Subject: Carrizo Energy Solar Farm (07-AFC-8)

Applicant's Responses to Comments from the CEC Workshop Held on

August 5, 2008

URS Project No. 27658060.01800

Caltrans Pilot Car Requirements

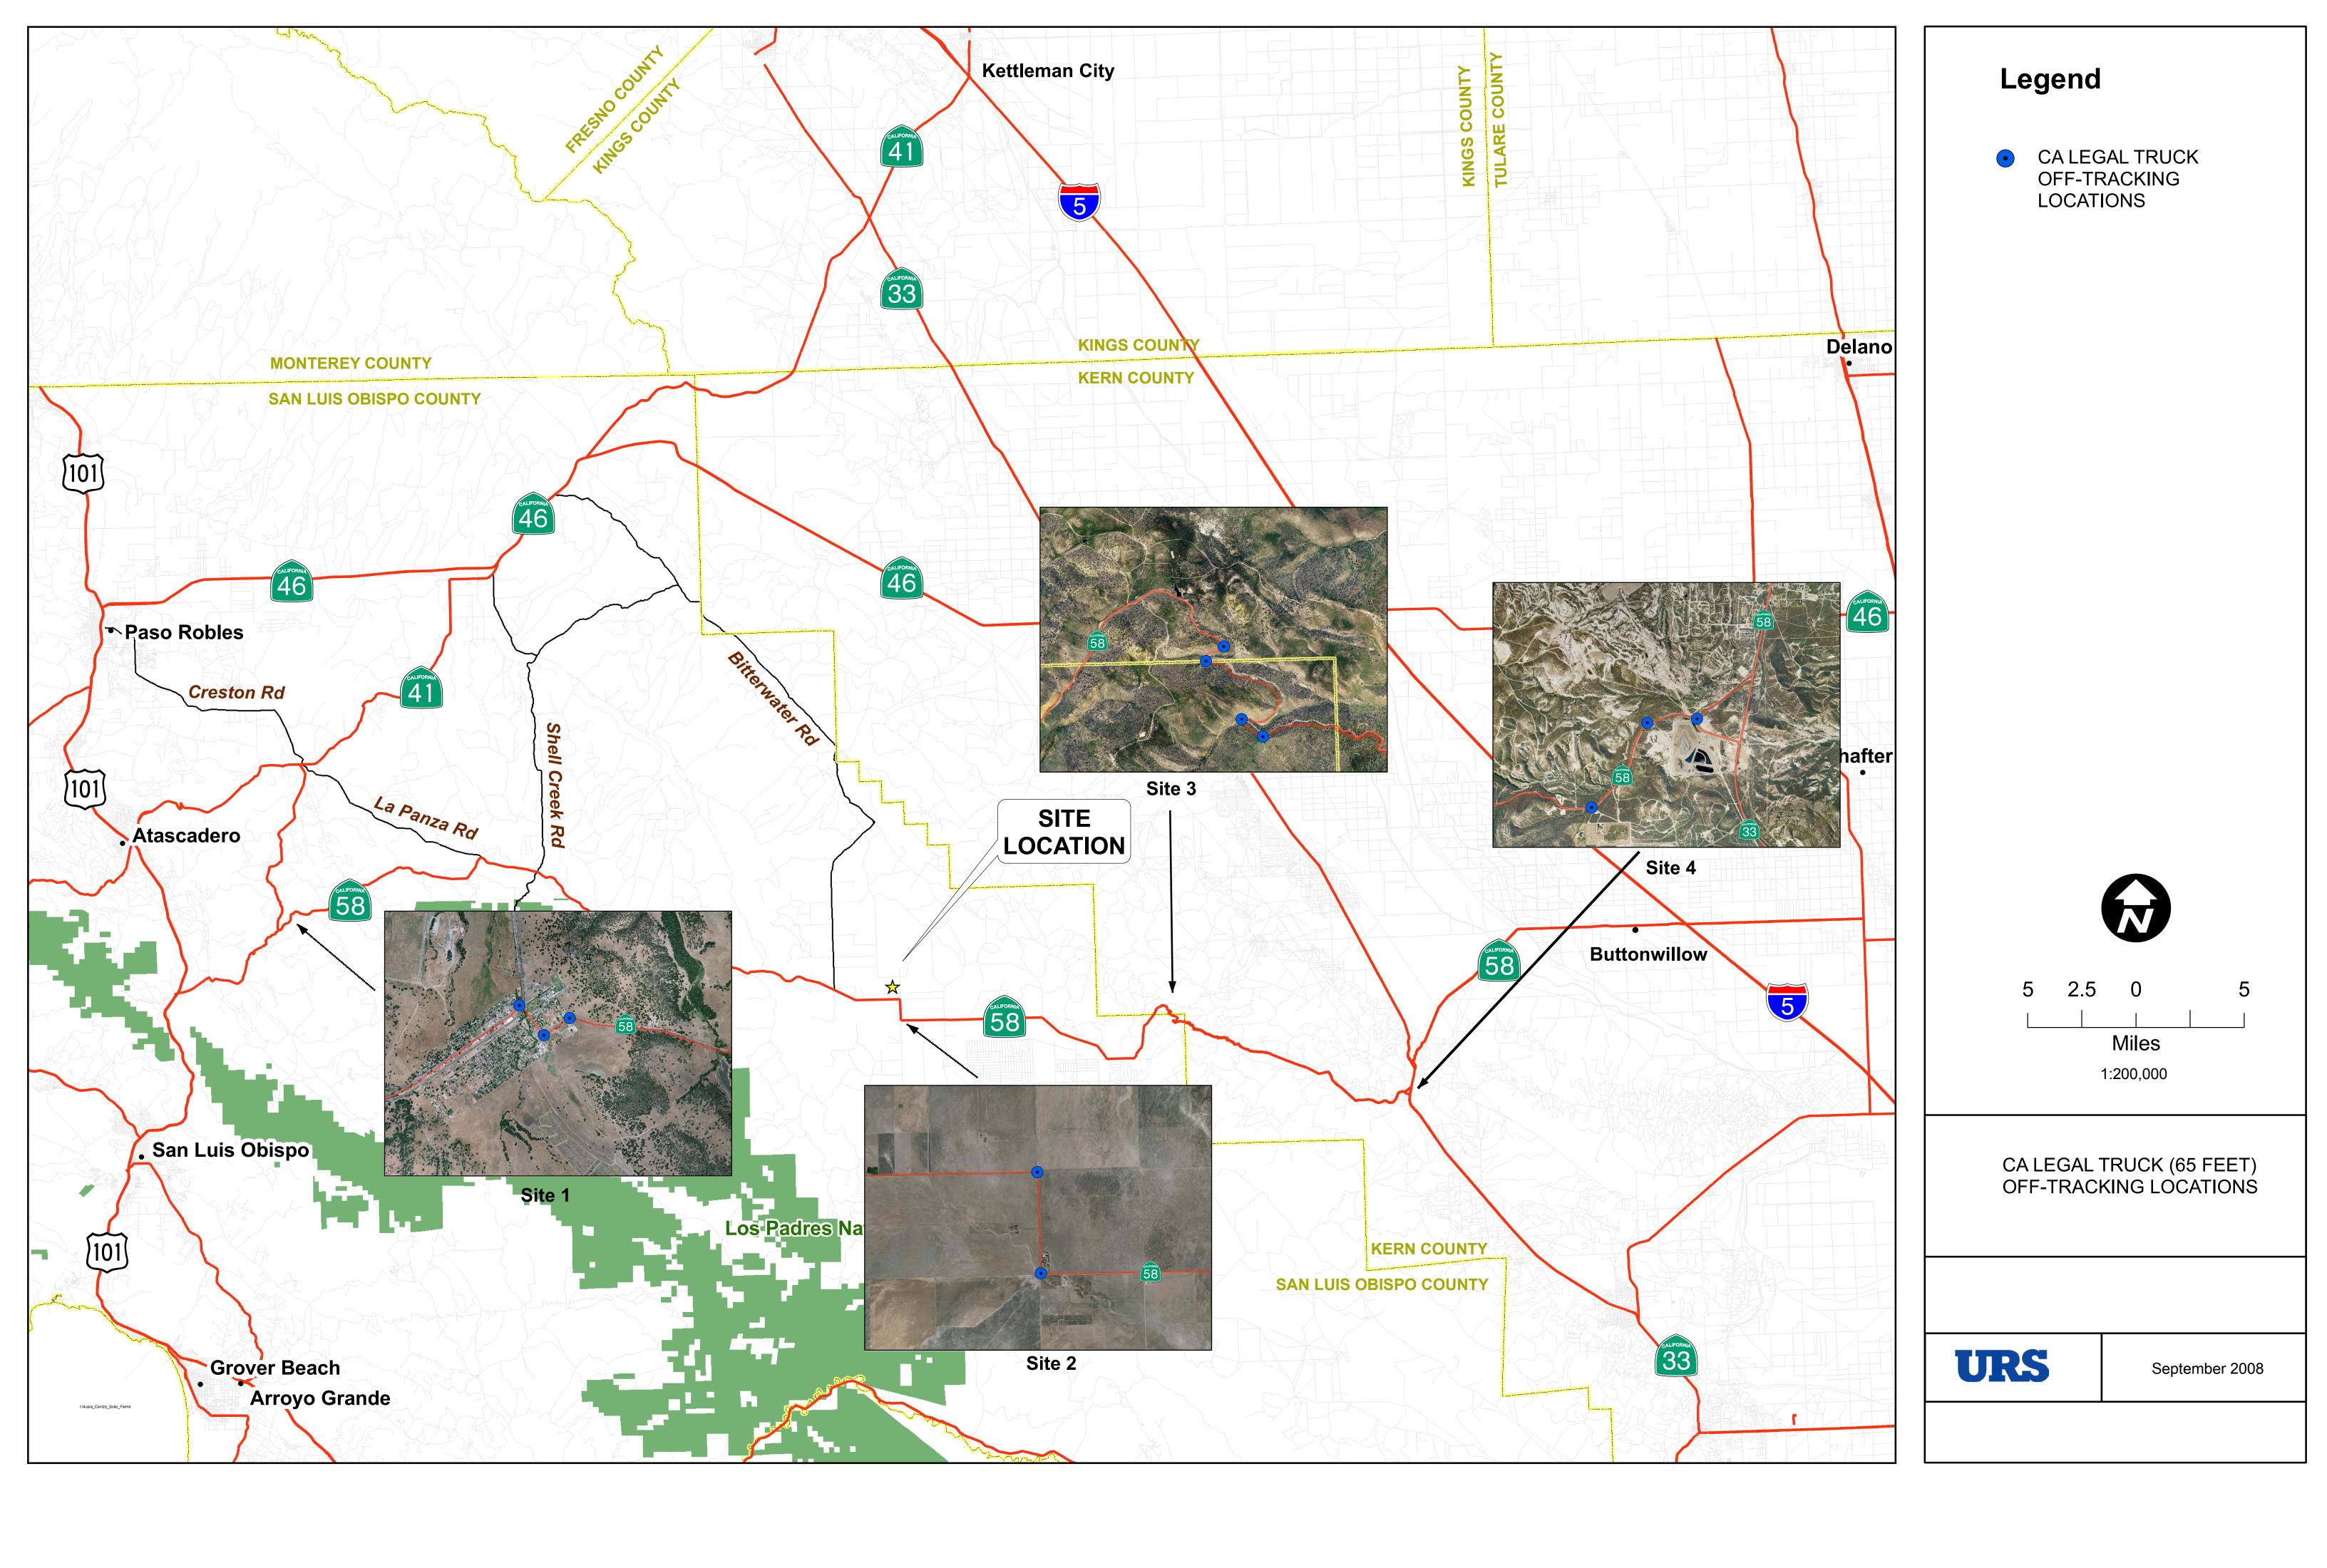
13	Mr. Young	page 37, line 14	And are all these pilot cars driven by CHP Officers?	Traffic	Caltrans regulates if a pilot/escort car or CHP escort are needed. This is determined by vehicle width (as shown below). Pilot/escort vehicles and CHP escorts are separate.
					Caltrans Pilot Car Requirements
					Route >10'0" to >11'0" to >12'0" to >13'0" to >14'0" to >15'0" to >16'0"
					11'0" 12'0" 13'0" 14'0" 15'0" 16'0" 16'0"
					Pilot Car Legend, Single Trip Permits Pilot Car Maps, Caltrans. 2008.

Note 3: Caltrans regulates if a pilot/escort car or CHP escort are needed. This is determined by vehicle width (as shown below). Pilot/escort vehicles and CHP escorts are separate.

Route	>10'0" to 11'0"	>11'0" to 12'0"	>12'0" to 13'0"	>13'0" to 14'0"	>14'0" to 15'0"	>15'0" to 16'0"	>16'0"
SR-58	1 Pilot Car	1 Pilot Car	2 Pilot Cars	2 Pilot Cars	2 Pilot Cars	CHP	CHP
